KAGRA Sensitivity for Observation Scenario Paper 2018

Yuta Michimura

Proposal for Update

Proposal for Update v20181005

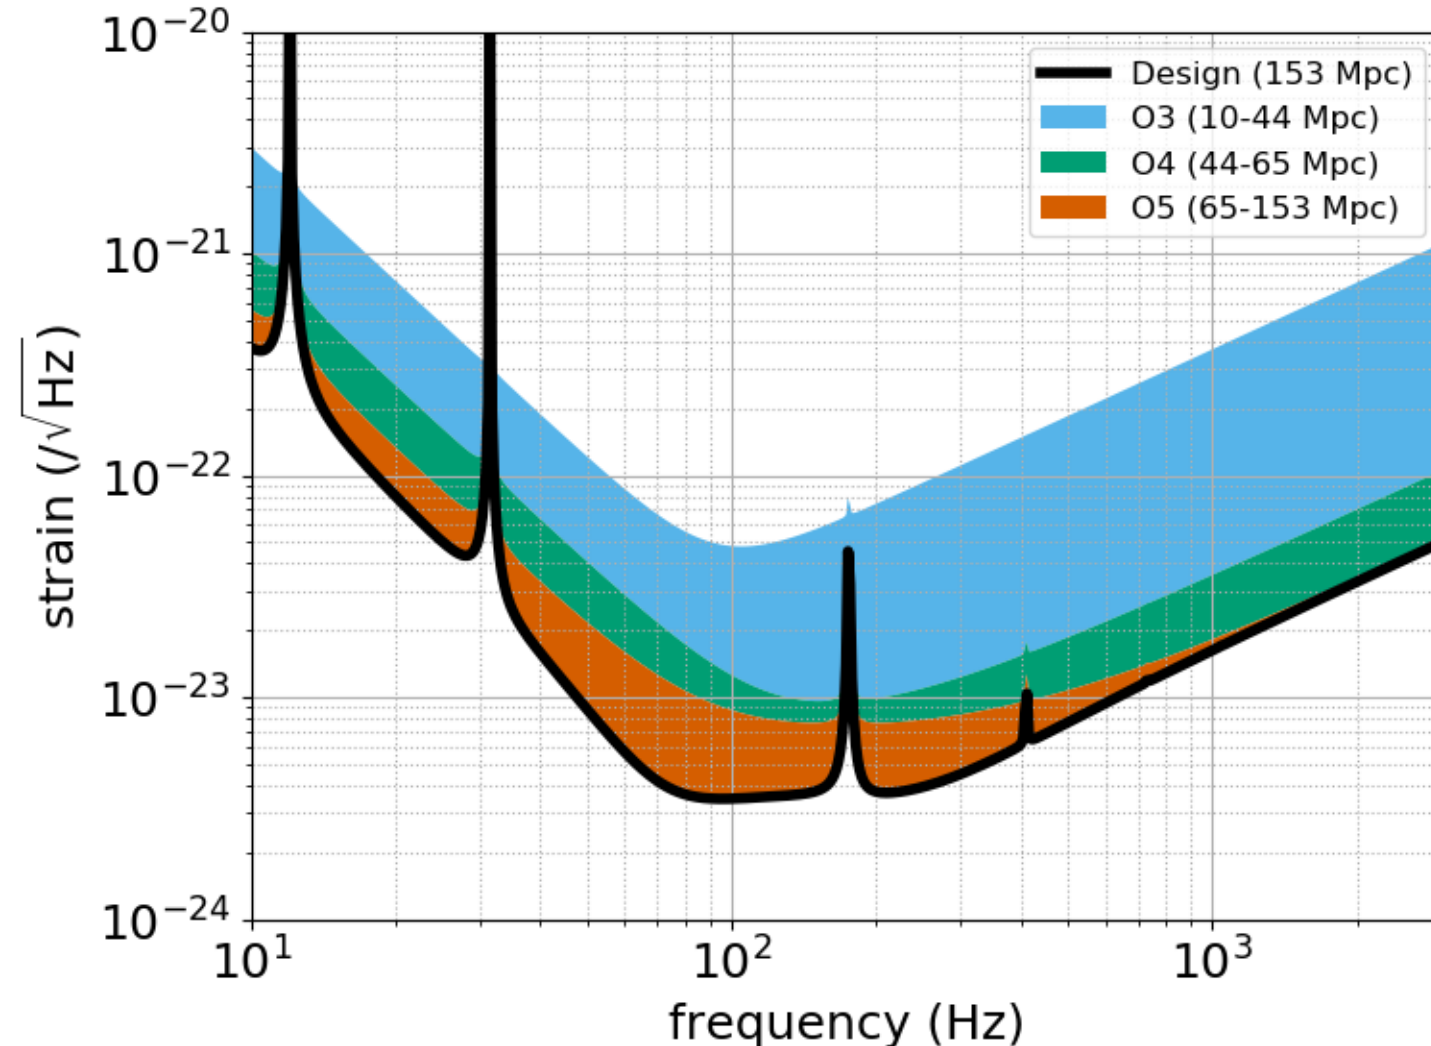
- 44 Mpc for O3 high sounds a bit too ambitious compared with 25 Mpc for Early high (2019.4-2020.3) in previous version
- People might think we should aim for the design sensitivity for O4
- DRSE in O4 might be too ambitious
